CB20-J-001A

IMPORTANT SAFETY RECALL

SURGE HOSE AND CHASSIS HARNESS RELOCATION – 20V-721

- Certain 2020MY N-Series Crew Cab Vehicles with Gasoline Engines 6.6 L8T (see VIN list)

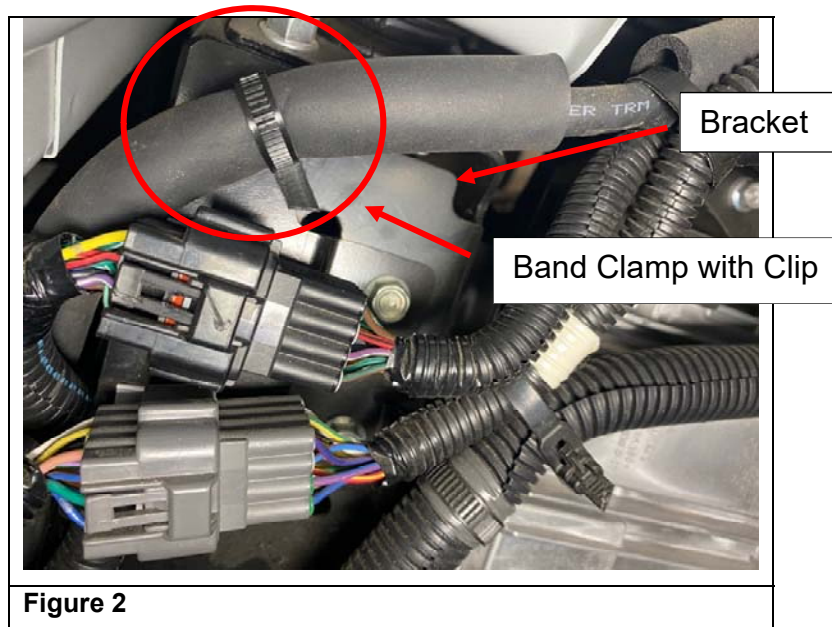
1. Shift vehicle to park, turn off engine, set parking brake, and block rear wheels.
2. Remove the rear engine cover. (See Figure 1.) The work will be performed in the area indicated.

Figure 3

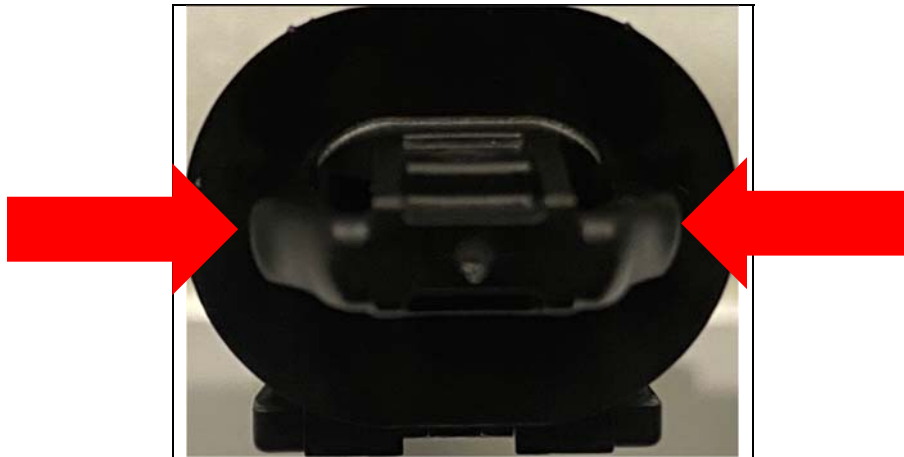
4. Use your fingers to depress the two tabs (See Figure 3) on the clip attaching the coolant surge hose band clamp clip on the back side of the bracket. Disengage the clip from the bracket.

NOTE: Do NOT remove the band clamp from around the coolant surge hose.

Figure 4

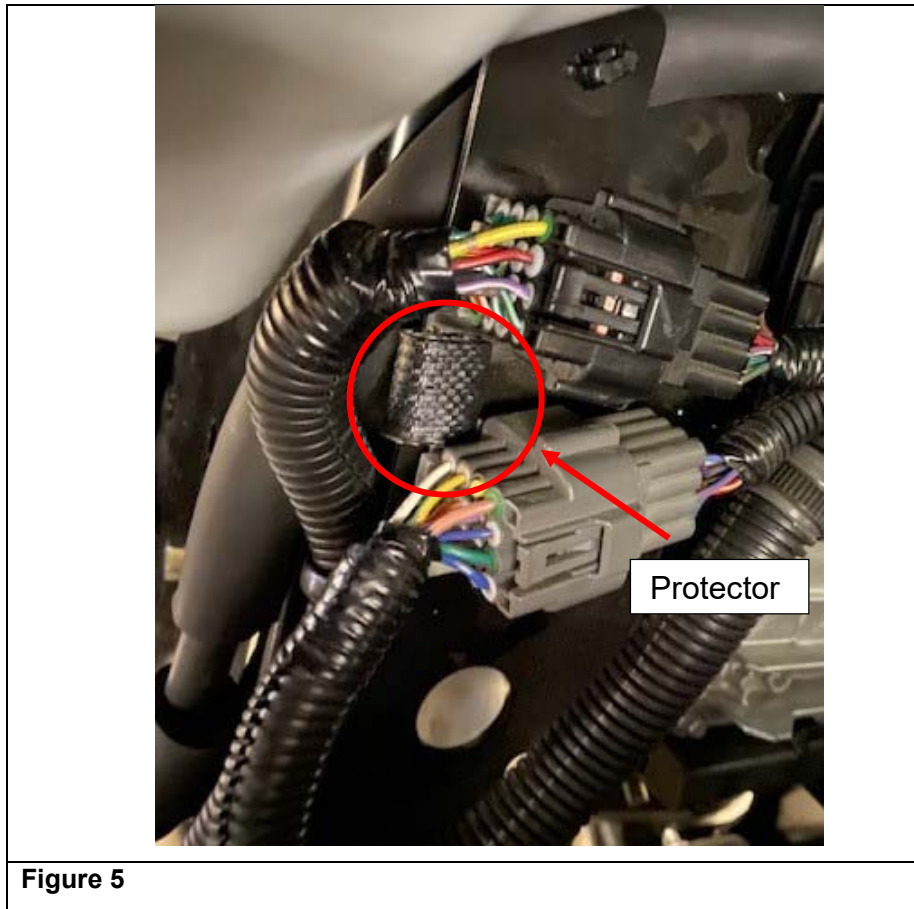
5. Relocate the coolant surge hose to behind the bracket and rotate the band clamp to install the clip into same hole in the bracket, but from the back side. (See Figure 4.) Ensure that both tabs on the band clamp clip fully engage into the bracket.

Figure 6

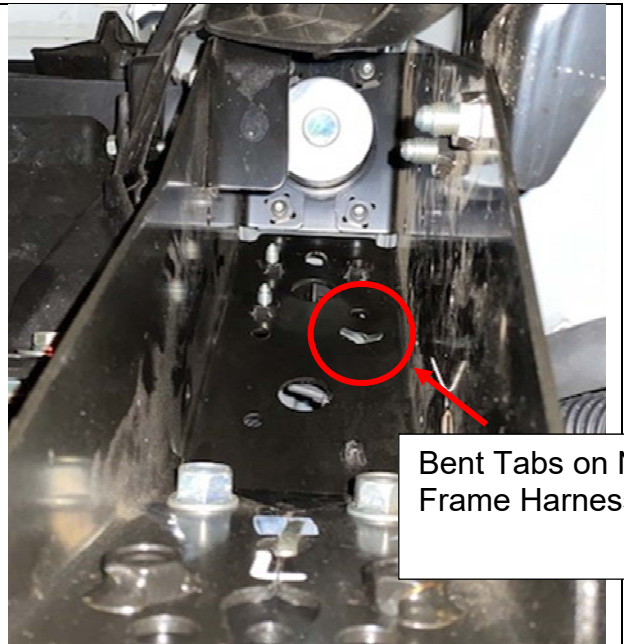
7. Route the harness going to the black connector as shown in Figure 6 and install the new frame harness clip in the hole of the cab mount bracket to secure the harness. Bend the tabs of the new frame harness clip outward on the back side of the cab mounting bracket. (See Figure 7.)

Figure 8

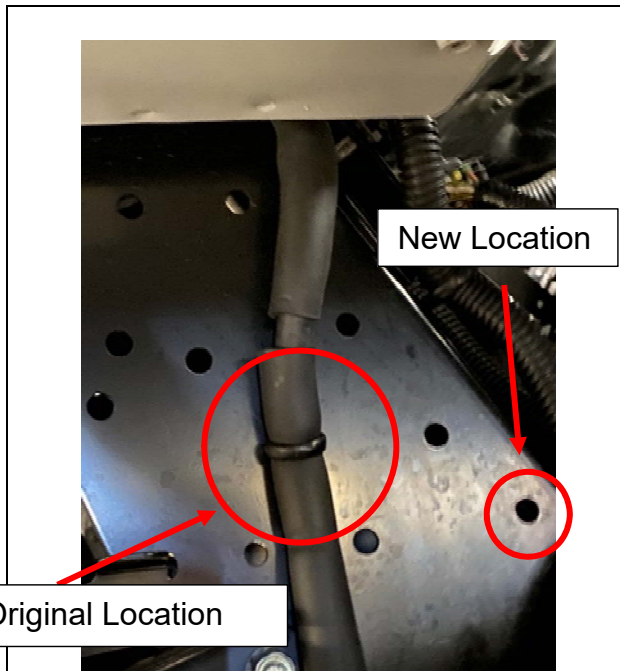
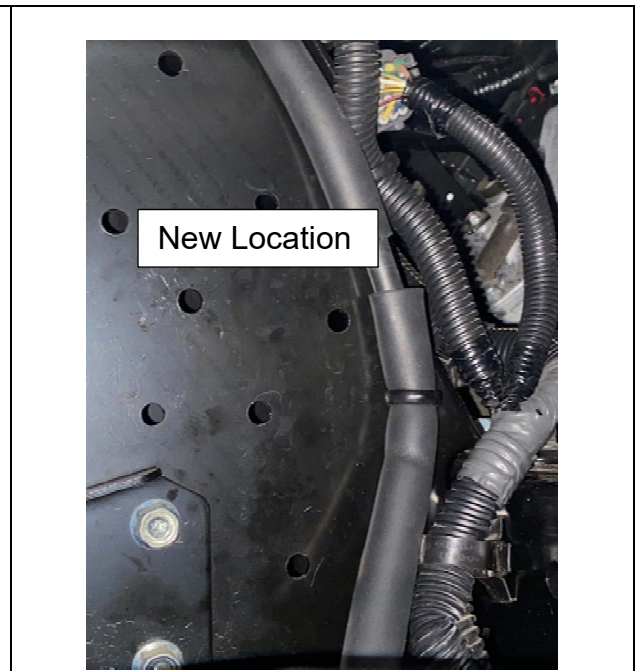
8. Locate the one existing frame harness clip securing the coolant surge hose to the body mount bracket. (See Figure 8.) Relocate the coolant surge hose and the frame harness clip to the new location as shown in Figures 8 and 9. Ensure that both tabs are properly bent outwards on the back side of the body mounting bracket.

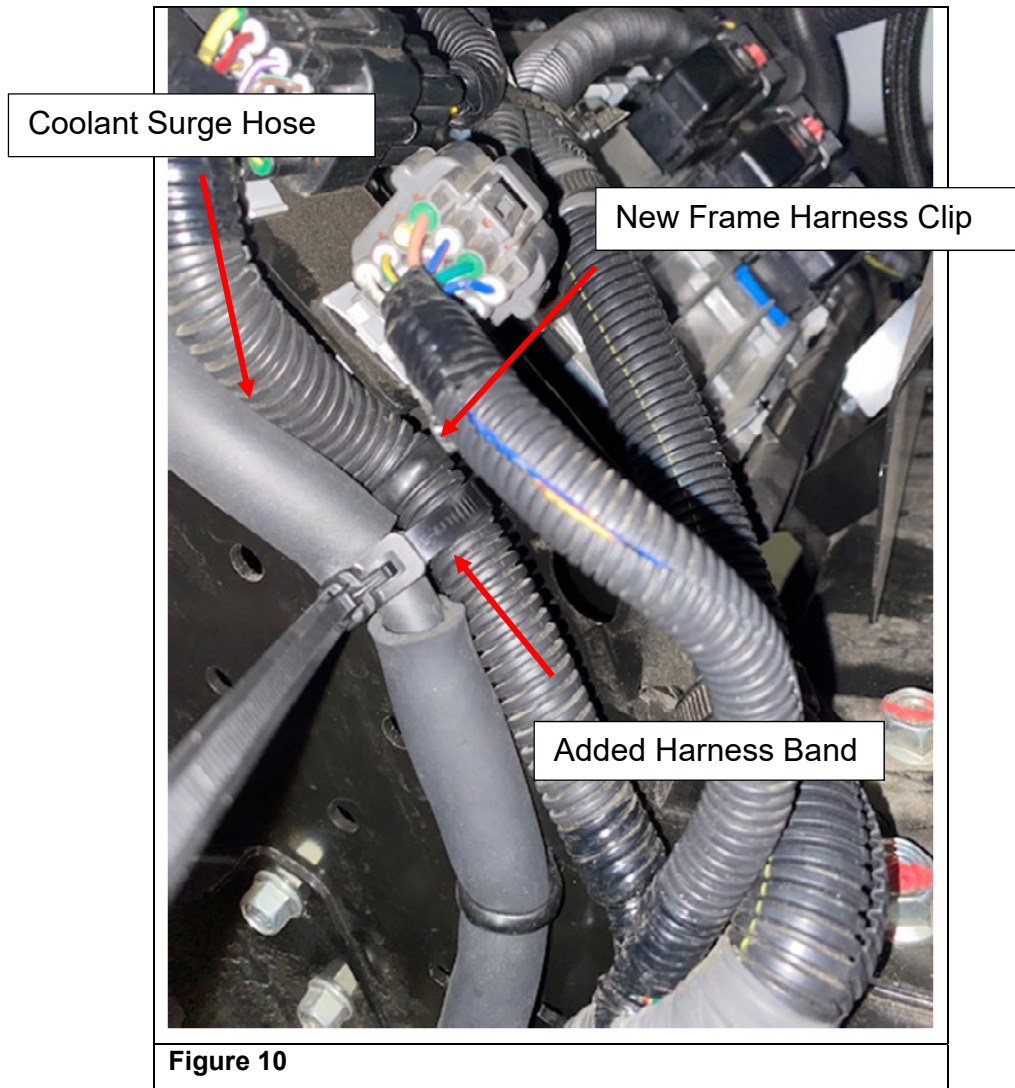
9. Use the new harness band to secure the surge hose to the harness just below the newly added frame harness clip. (See Figure 10.)
